# Permit Fact Sheet

Permit Number:	WI-0067409-01-0
Permittee Name:	Rob-n-Cin Farms LLC
Address:	5545 County Road Y
City/State/Zip:	West Bend WI 53095
Discharge Location:	5545 County Road Y, West Bend, WI 53095; S25 T11N R20E, Township of Trenton, Washington County
Receiving Water:	Unnamed Tributaries within the Cedar Creek Watershed, Lake Michigan Drainage Basin and groundwaters of the state

Subject: Evaluation Review for Lot and waste storage facilities 1 & 2, feed storage areas and runoff controls, and waste transfer systems at Rob-N-Cin Farms LLC in Washington County - FURTHER ACTIONS ARE REQUIRED

Subject: Conditional Approval of Plans & Specifications for a waste storage facility 4 (WSF4) at, Rob-N-Cin Farms LLC at NW¼ SE¼ of T11N, R20E, Section 25 in Trenton Township, Washington County

Figure 1: Labeled map of Rob-n-Cin Farms. Image Source: Google Earth.

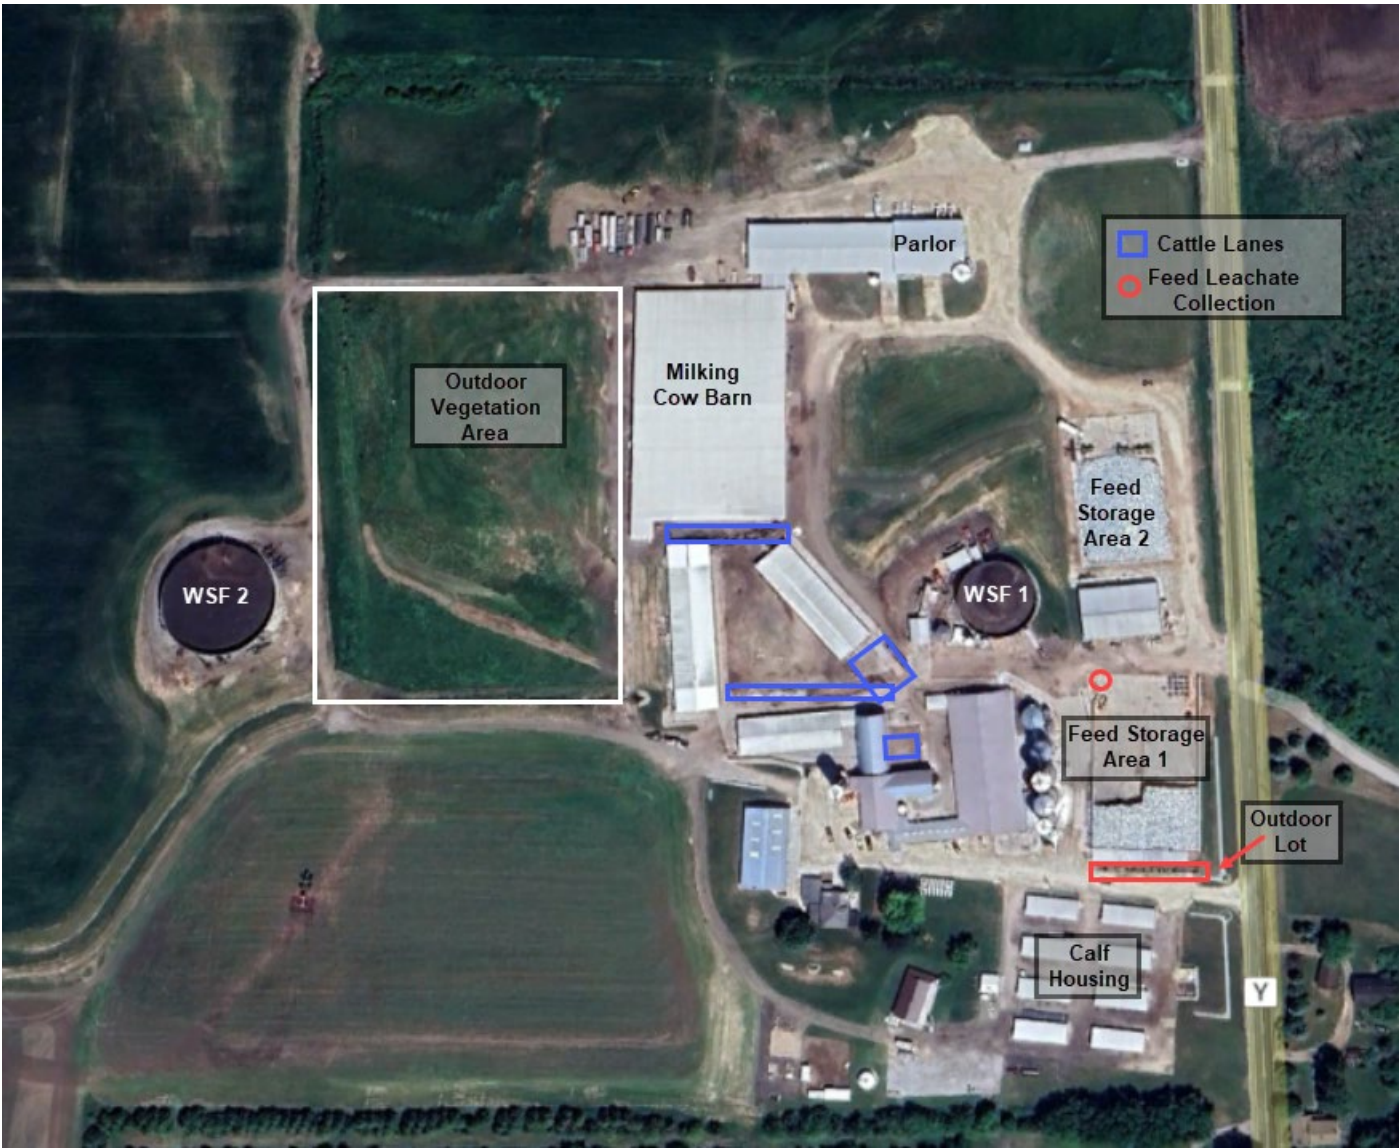
Rob-n-Cin Farms operates one outdoor lot located on the southside of feed storage area 1. The outdoor lot houses heifers. No engineered runoff controls were observed. Runoff from the outdoor lot flows east into a grassed area and is cleaned out with a skidsteer. R. Roden explained the plan is to eventually eliminate the outdoor lot when the barn expansion happens. Ziegler explained the outdoor lot would need to be evaluated as part of the final application. The group brainstormed some potential interim practices for the outdoor lot including: replacing the gutters and adding a curb to the end of the lot to prevent manure from leaving.

Rob-n-Cin Farms operates cattle lanes between barns. The frequency of use of the cattle lane depends on the animals housed in the surrounding barns. The cattle lanes by the new milking cow barn are used multiple times a day to move the cows to the parlor. R. Roden explained that the future plan is to move all milking cows into the new barn when expanded which will minimize the use of the cattle lanes. The group discussed potential changes to the cattle lanes including: installing gutters, installing roofs, scraping the lanes more often, and installing curbs on the lanes.

- Lack of runoff controls for the outdoor lot
- Mortality composting
- No runoff controls for FSA 2
- Cattle lanes
